ADDENDUM NO. 1

LOWER VALLEY WATER DISTRICT

PANORAMA VILLAGE LIFT STATION 19 (PACKAGE 4)

BID No. 24-0105-01

JOB NO. 21-117
4 SHEET NUMBER 8
E4.0

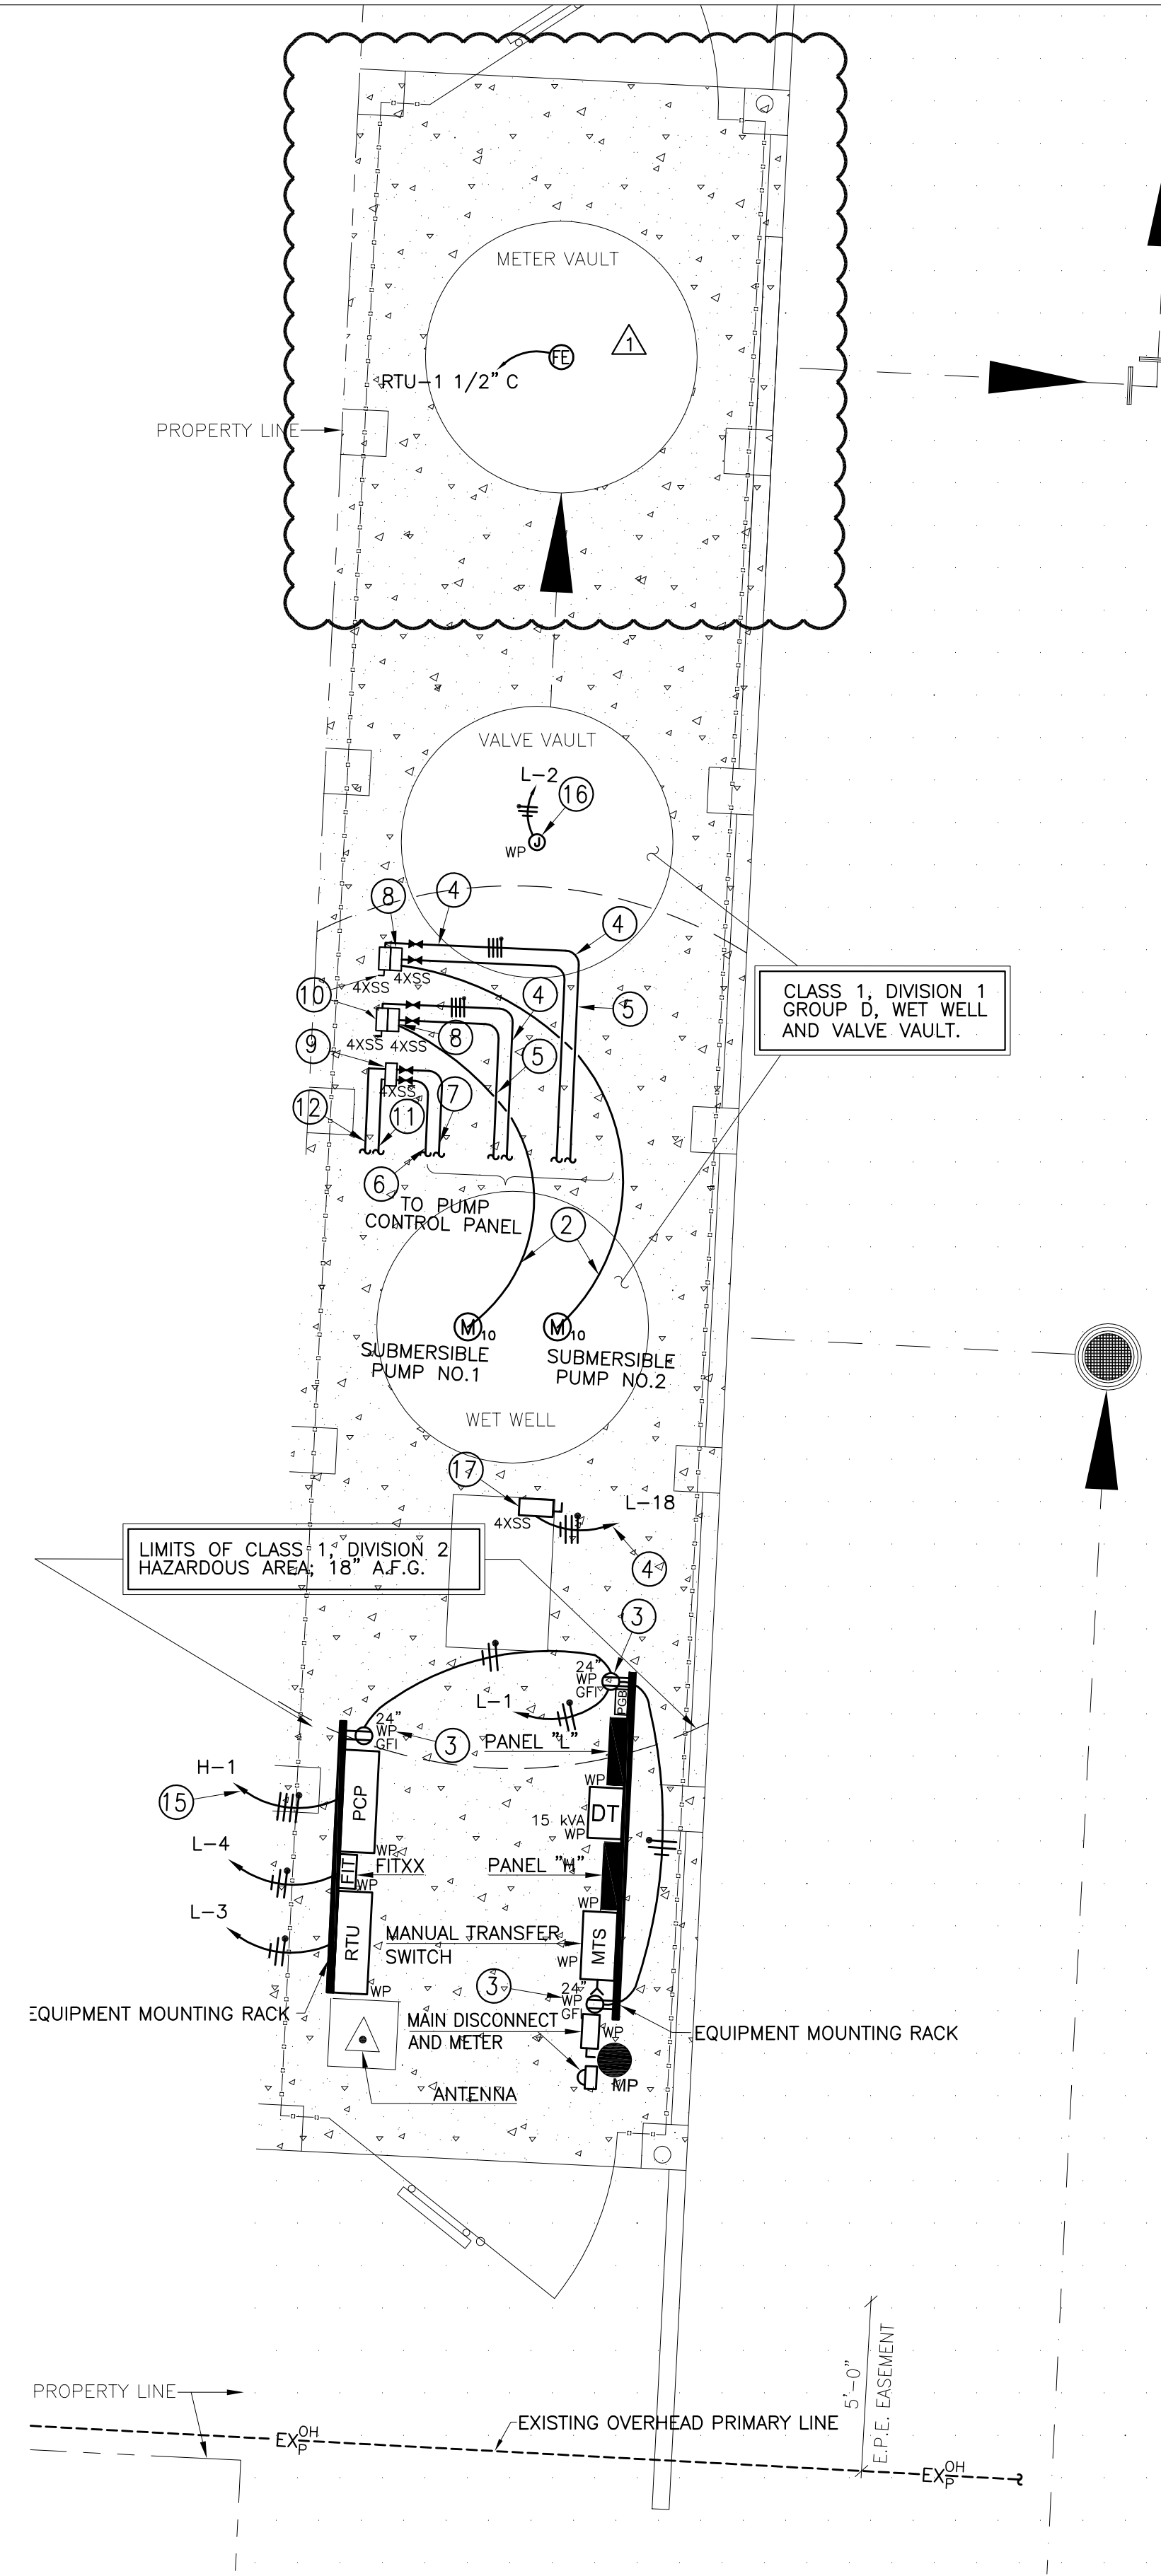
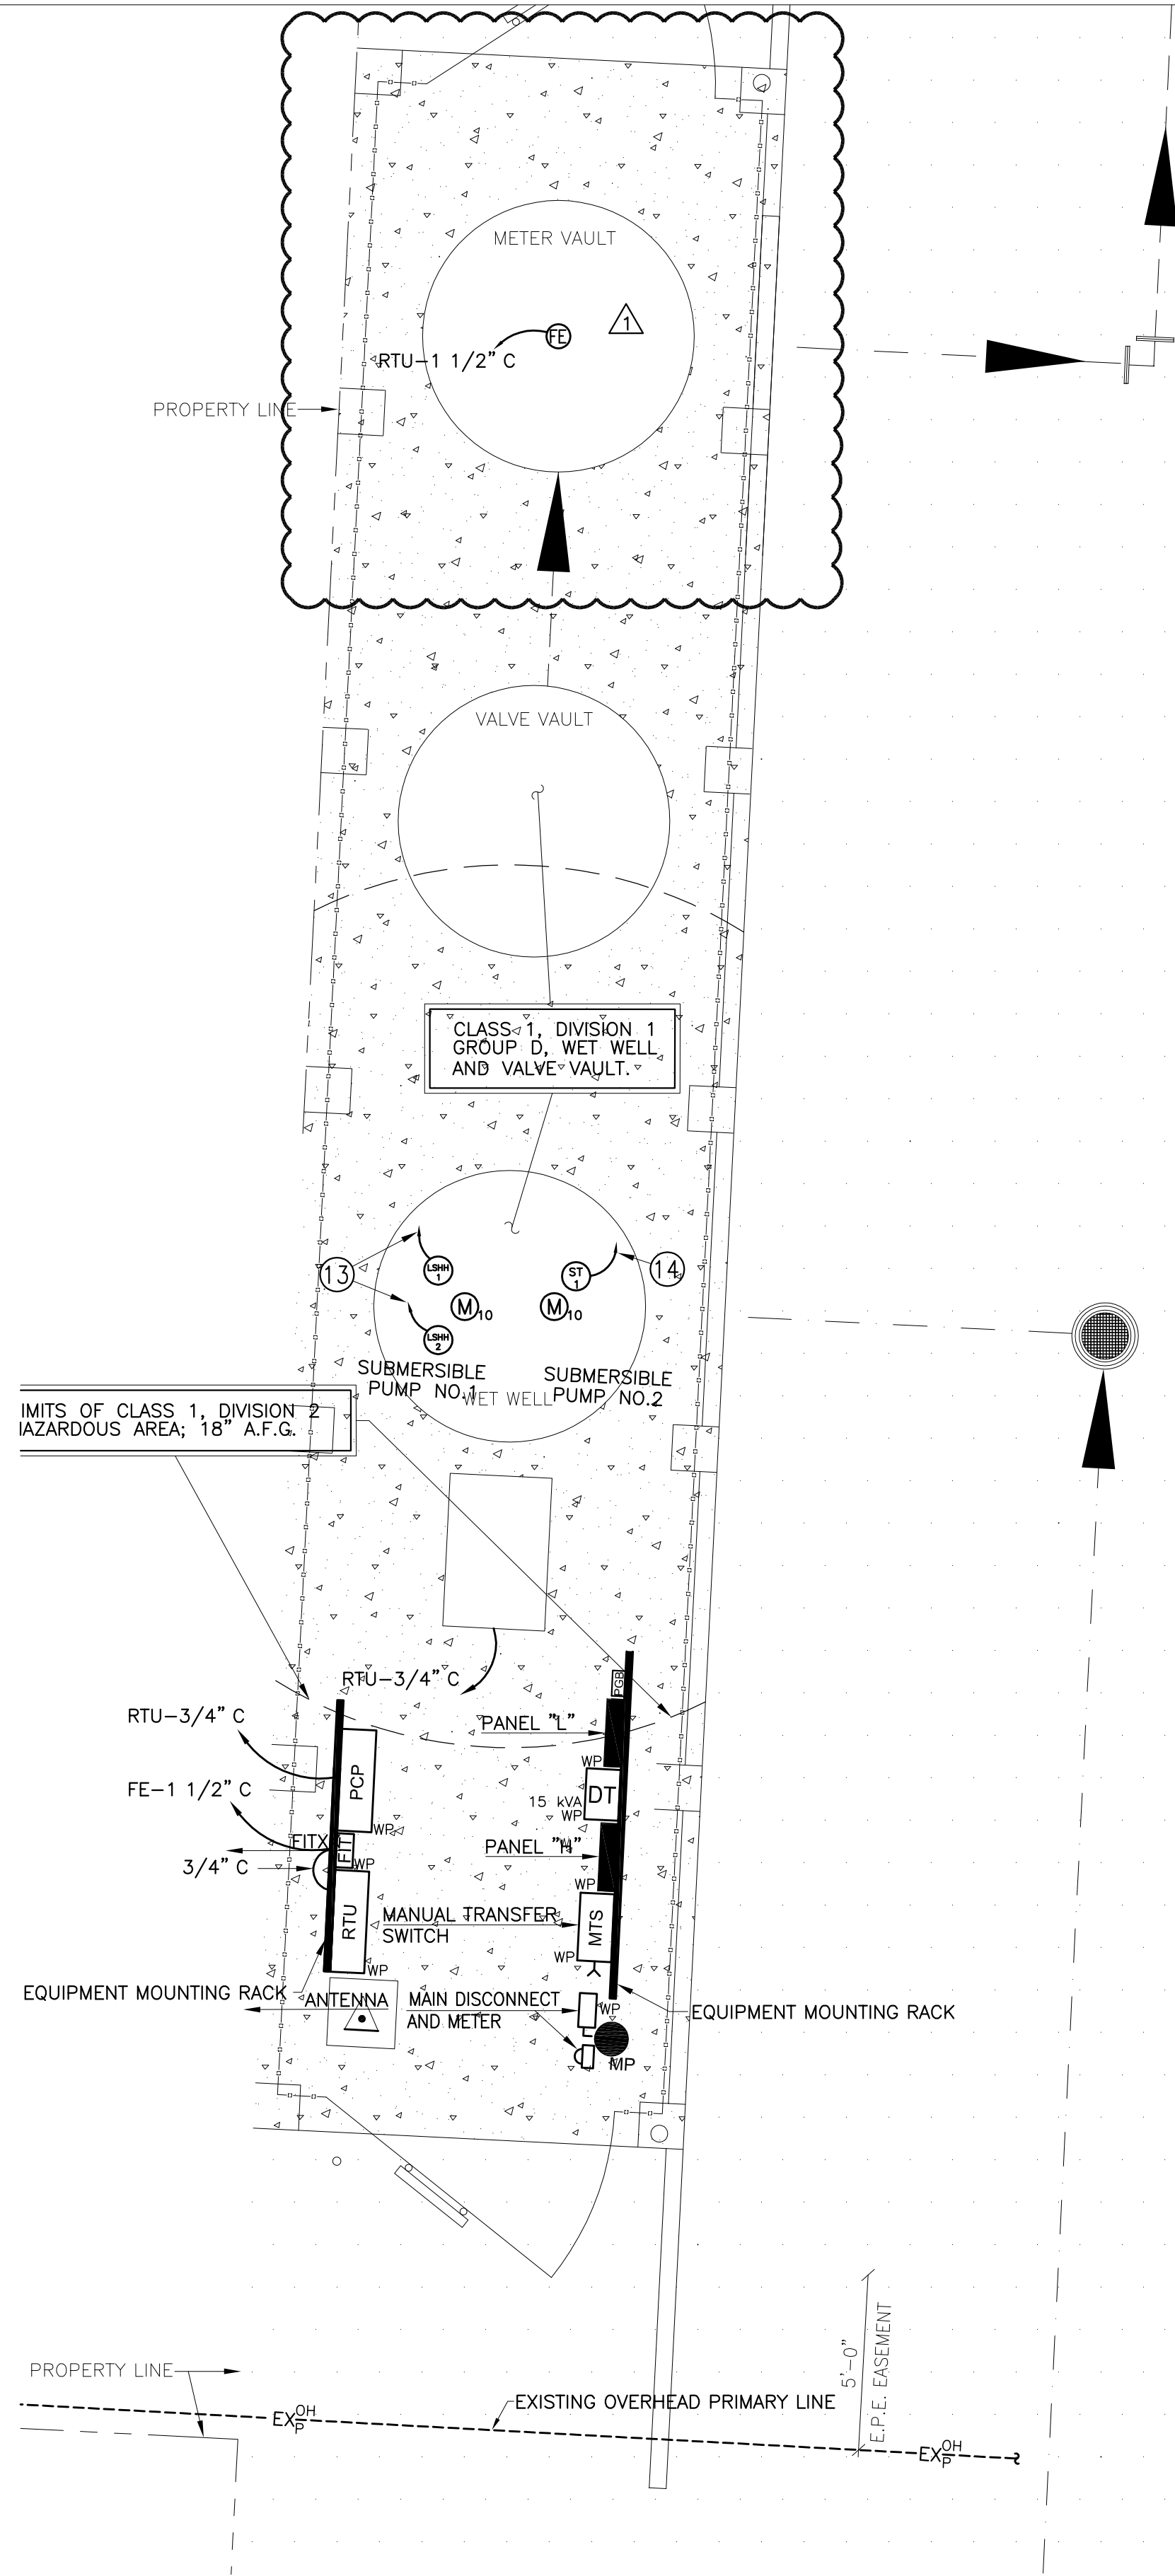
REV.	DATE	BY	DESCRIPTION
1	12/22/23	G.A.	ADDED VAULT FOR FLOW METER
